TEXAS COMMISSION ON ENVIRONMENTAL QUALITY

Re: Edwards Aquifer, Comal County
NAME OF PROJECT: Rockfield RV Park, located on the east side of FM 2722 about 2.4 miles north of the intersection of Hwy. 46, New Braunfels, Texas
TYPE OF PLAN: Request for Approval of a Water Pollution Abatement Plan (WPAP); 30 Texas Administrative Code (TAC) Chapter 213 Edwards Aquifer
Edwards Aquifer Protection Program ID No. 2832.00, Investigation No. 702727, Regulated Entity No. RN105618391

RE: **Rockfield RV Park Water Pollution Abatement Plan Application**, EAPP #2832.00

RE: Rockfield RV Park Water Pollution Abatement Plan Application

WATER POLLUTION ABATEMENT PLAN
SITE PLAN

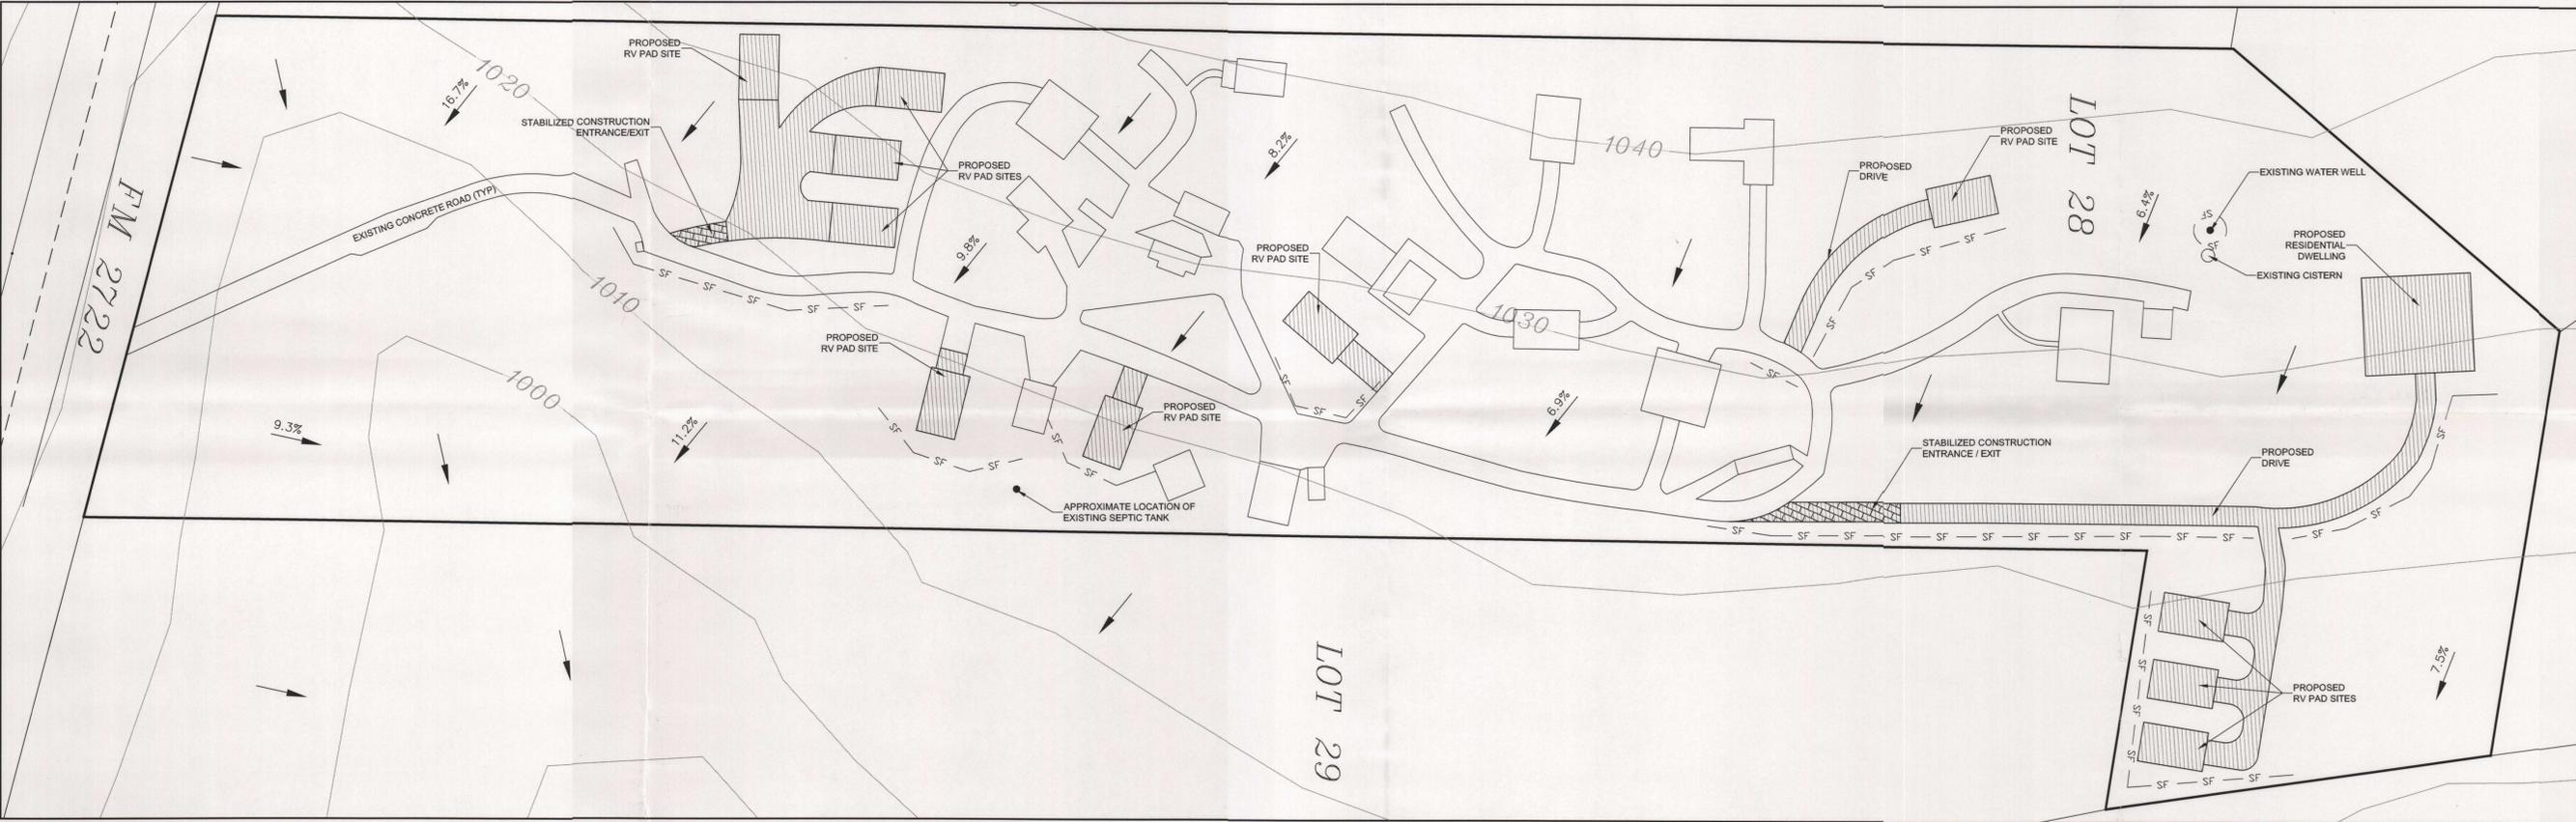
- 3. Details of proposed construction entrance/exit and of the silt fence (BMPs) should match their descriptions. See sections 1.4.2 and 1.4.3 of TCEQ's Technical Guidance Manual (RG-348). Please update (revise).*

REVISIONS:
10-29-08 REVISED BMP DETAILS ACCORDING TO TCEQ LETTER DATED 10-24-08

The details shown on the construction plans in the WPAP have been revised to match the descriptions in Sections 1.4.2 and 1.4.3 of TCEQ's Technical Guidance Manual (RG-348).
